SUBJ: **Addendum 1 – Clarifications to the Specifications and Responses to Vendor's Questions**

BID ITEM: **Bid Item #23-150 Construction - Airfield Electrical System Upgrade for Runways 5-23 & 11-29 for Augusta, GA – Daniel Field Airport**

ADDENDUM NO. 1

AIRFIELD LIGHTING & WIRING PLAN
- RUNWAY 11/29
- PART 3 (ADD)
E24
Sheet 48 of 52

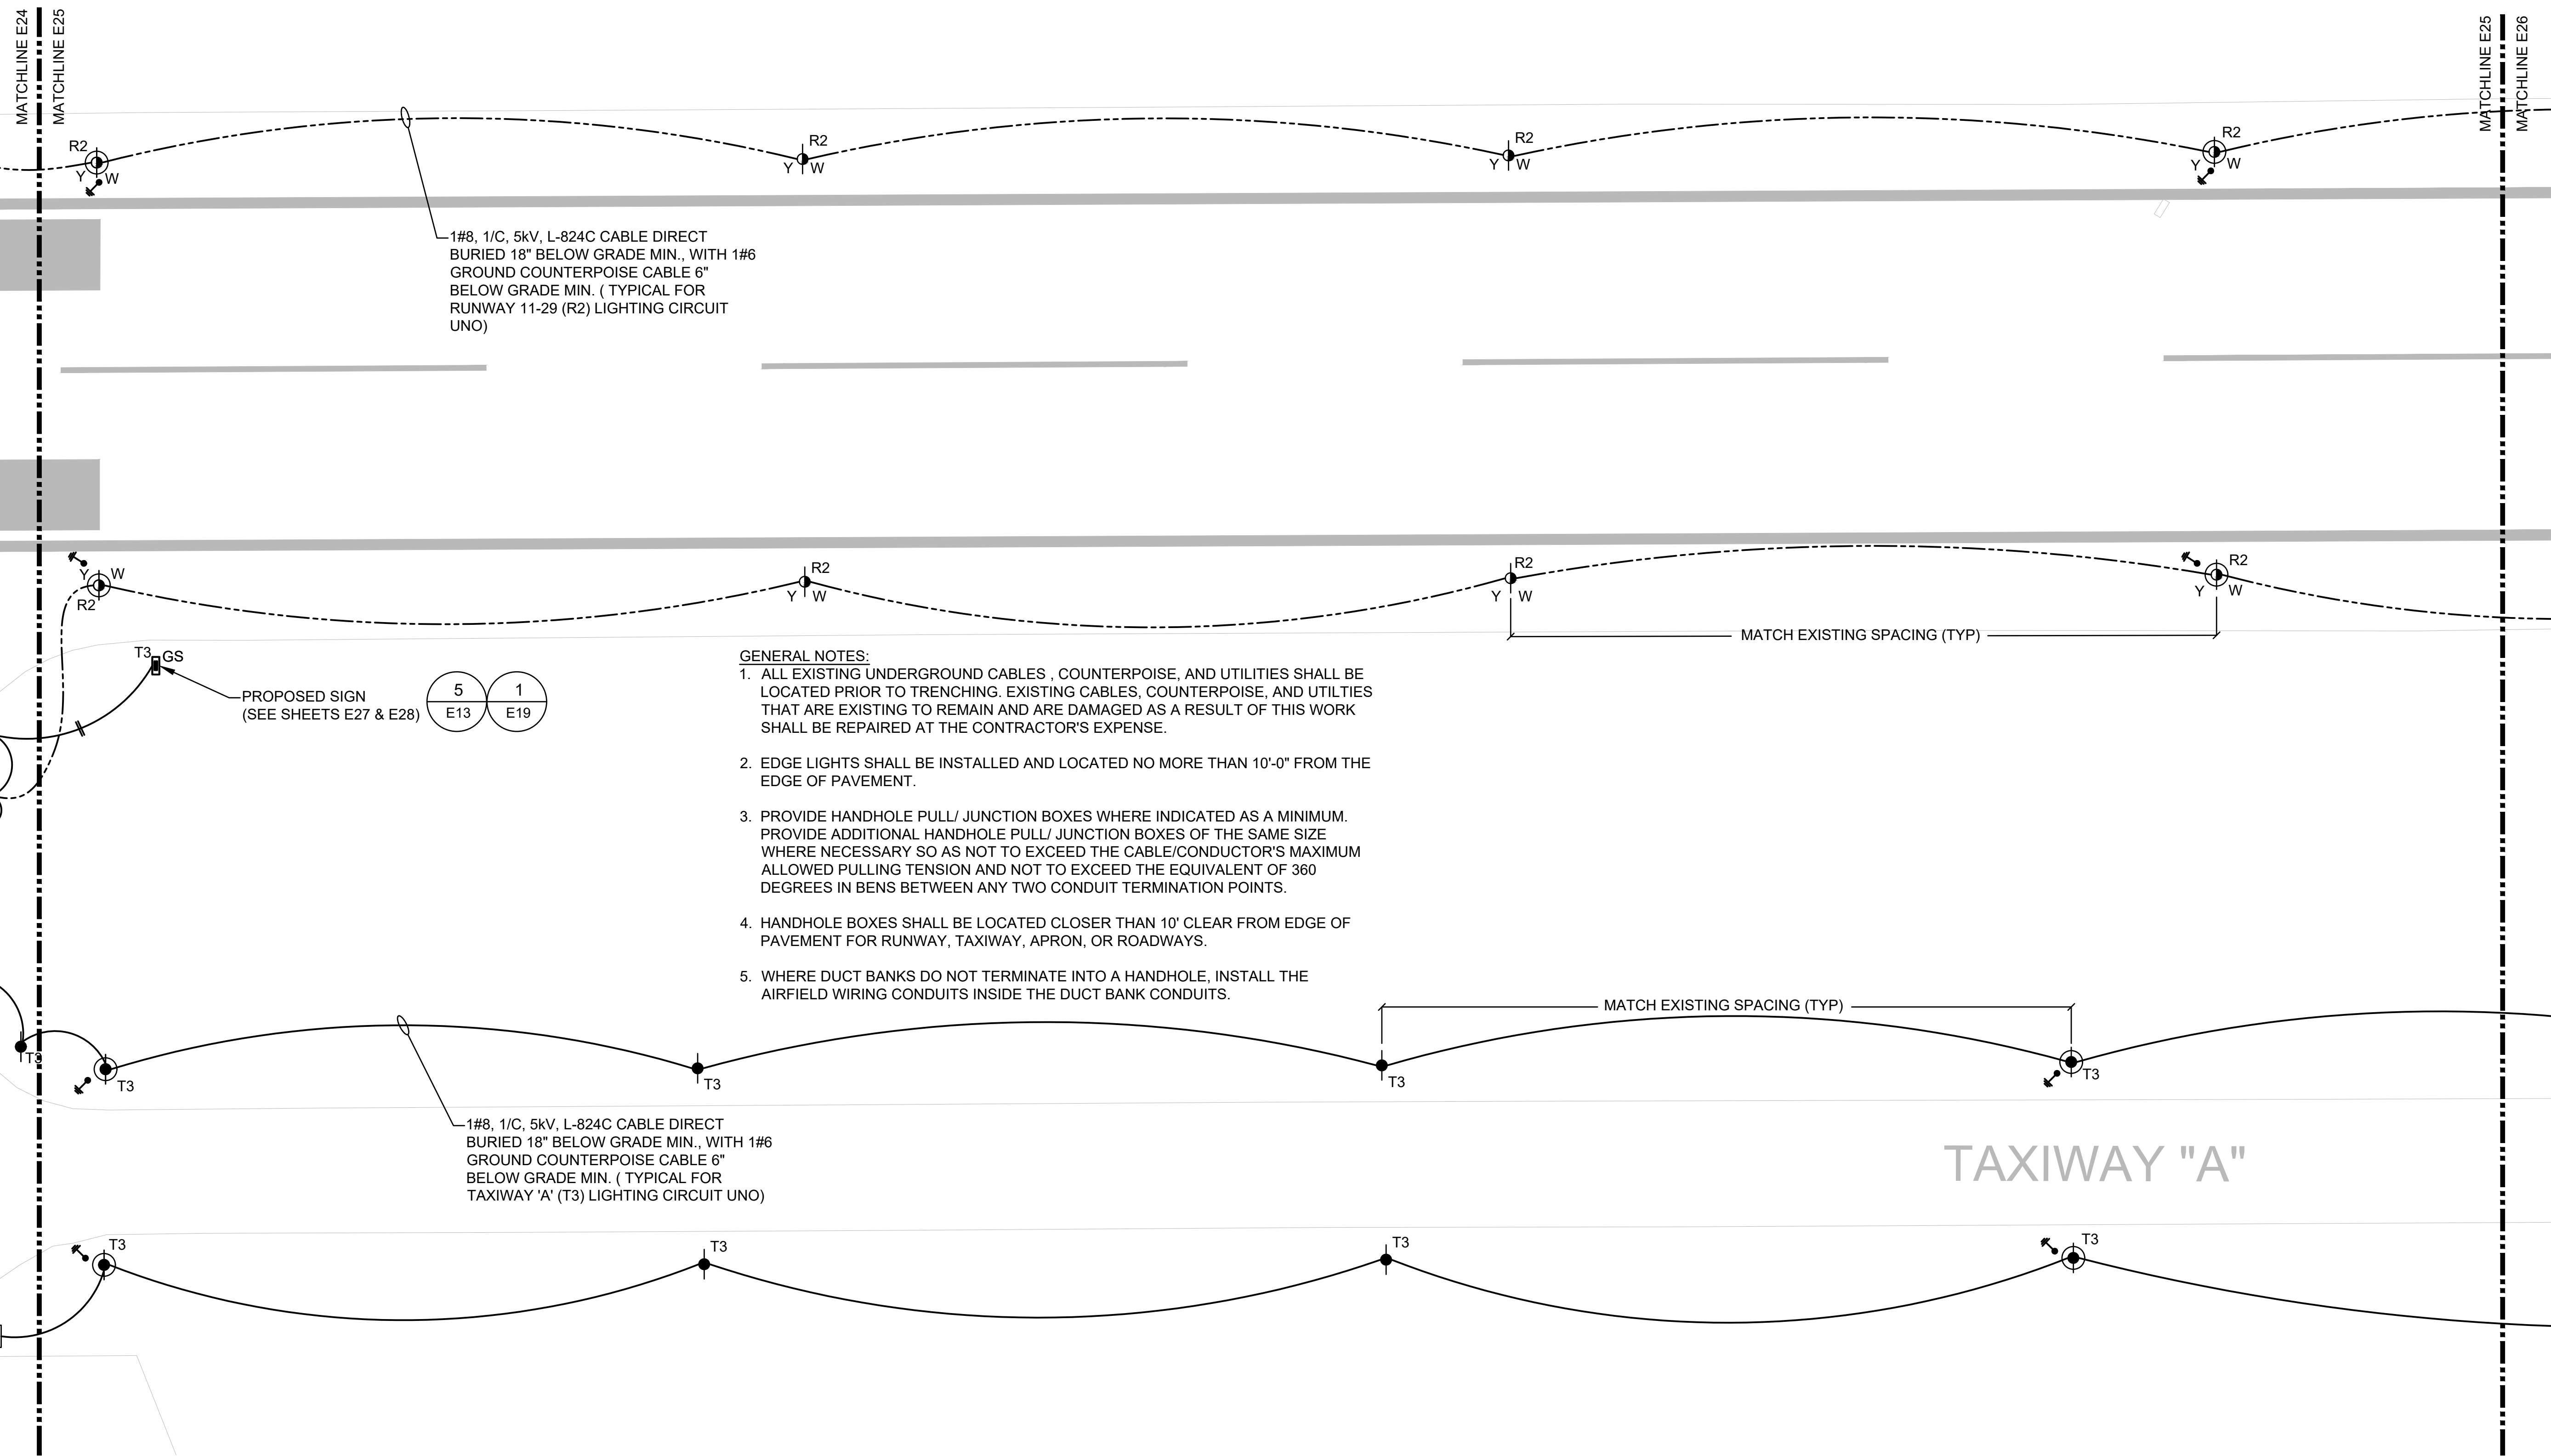
- Scale of this sheet revised from 1"-50' to 1"-25'.
 - Deleted all Field Lightning Arrestors.
 - Deleted Keynote 1 associated with Field Lightning Arrestor.

- ALT (Alternate) abbreviation and wording revised to ADD (Additive Bid).
 - Circuit Wiring/Routing shown for Runway 11/29 (R2) & Taxiway A (T3) Circuits.

AIRFIELD LIGHTING & WIRING PLAN - RUNWAY 11/29 - PART 5 (ADD)
E26
 Sheet 50 of 52

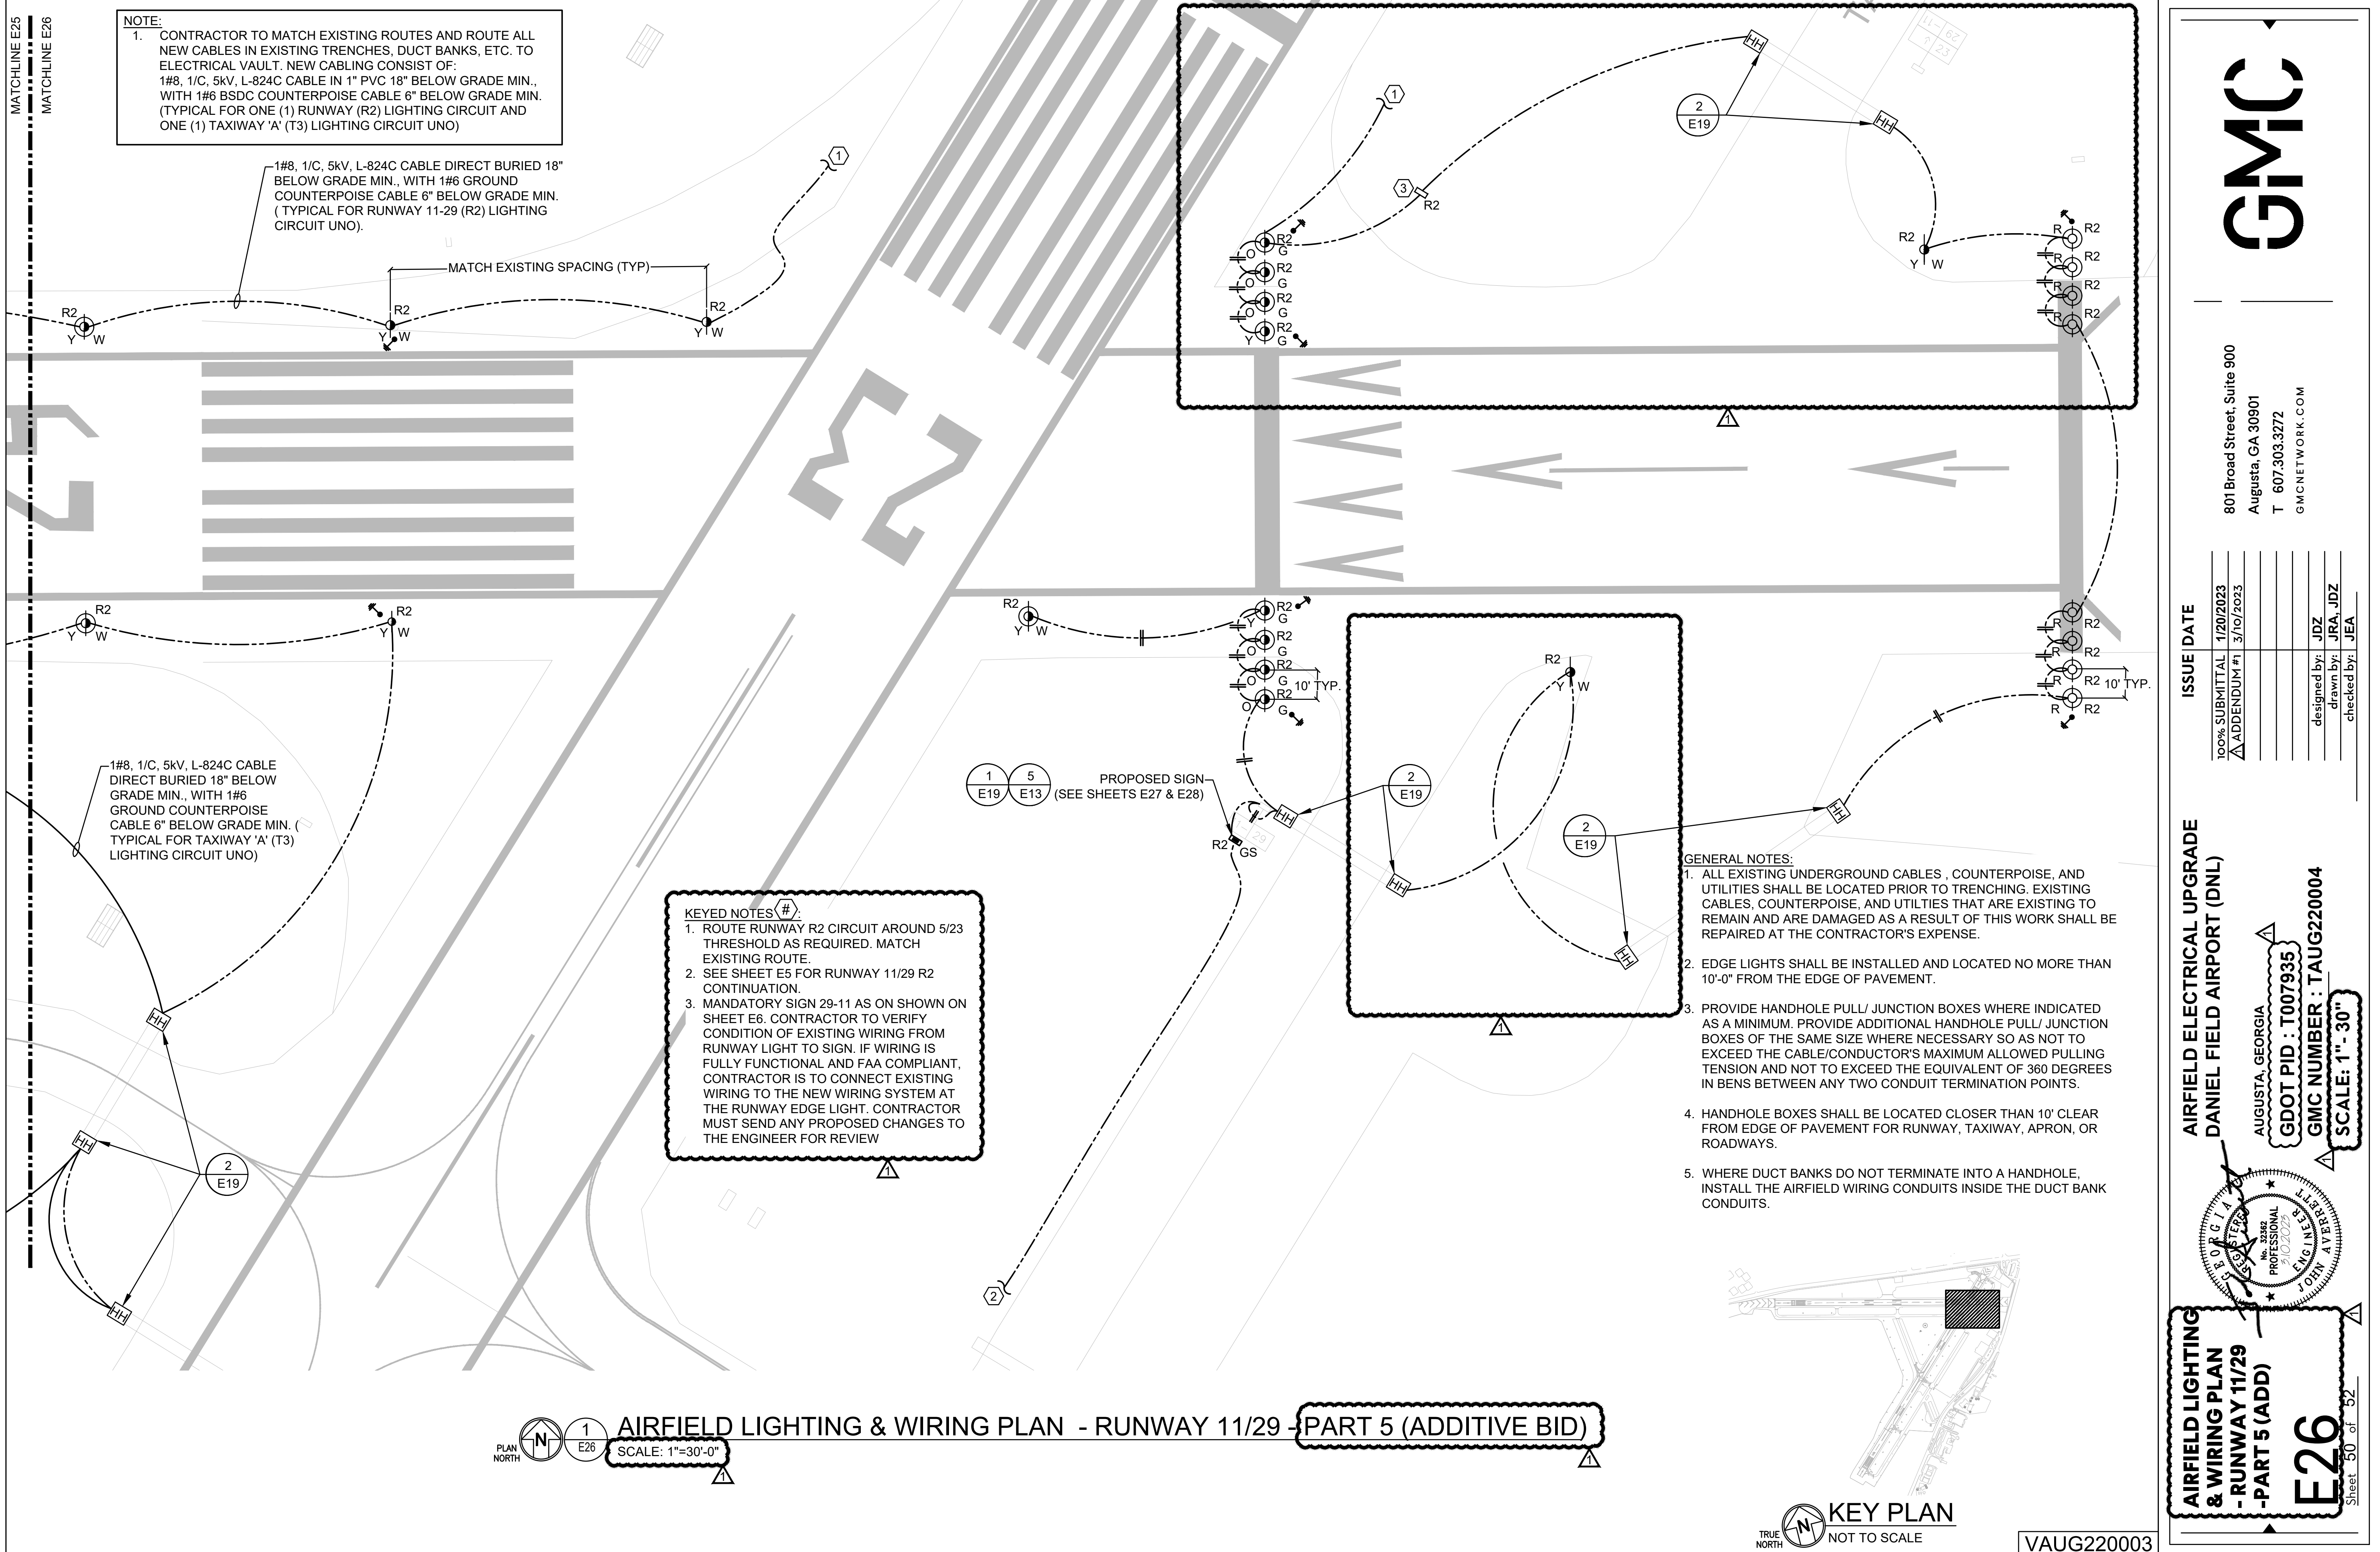
- Y. **Replace Sheets E26** – Airfield Lighting & Wiring Plan – Runway 11/29 – Part 5 with revised Sheets E22 - E23 attached to this Addendum 1.
- Scale of this sheet revised from 1"-60' to 1"-30'.

- Deleted all Field Lightning Arrestors.
 - Keynote 1 revised to state Route Runway R2 Circuit Around 5/23 Threshold as required. Match existing route.

- Added Keynote 2.

- ALT (Alternate) abbreviation and wording revised to ADD (Additive Bid).
- Circuit Wiring/Routing shown for Runway 11/29 (R2) & Taxiway A (T3) Circuits.
- Mandatory sign 29-11 added to Runway 11/29 (R2) Circuit.
- Added two runway edge lights near threshold.

**AIRFIELD SIGN
CHART PLAN
- RUNWAY 11-29
ADDITIVE BID**

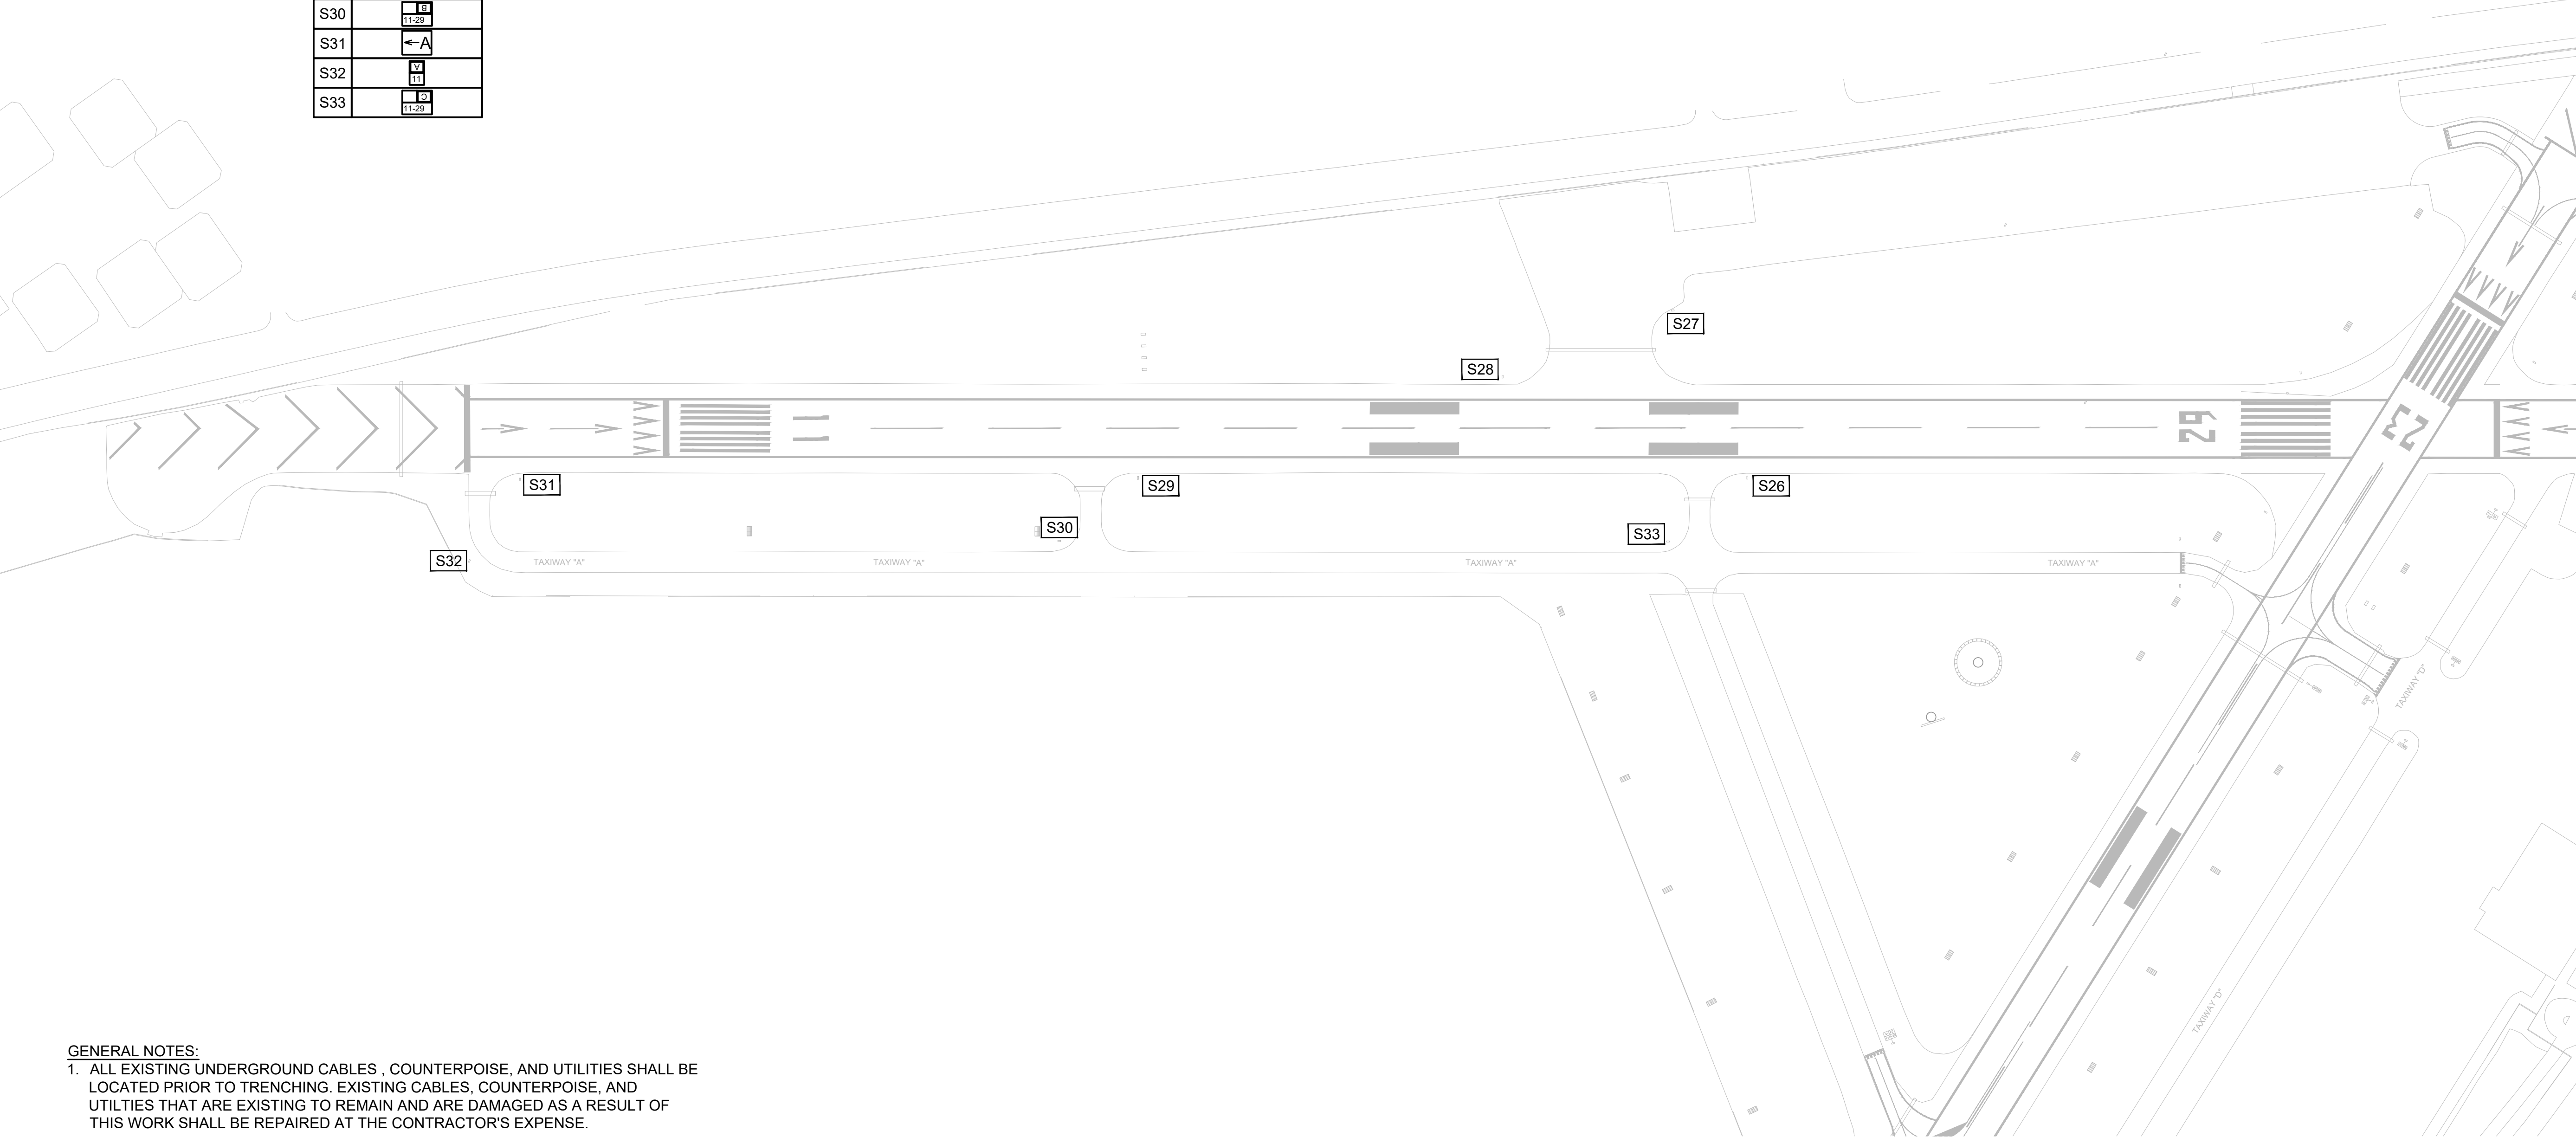
- Scale of this sheet revised from 1”-300’ to 1”-150’.
- Sign S28 directional arrow revised to point in the right direction.
- ALT (Alternate) abbreviation and wording revised to ADD (Additive Bid).
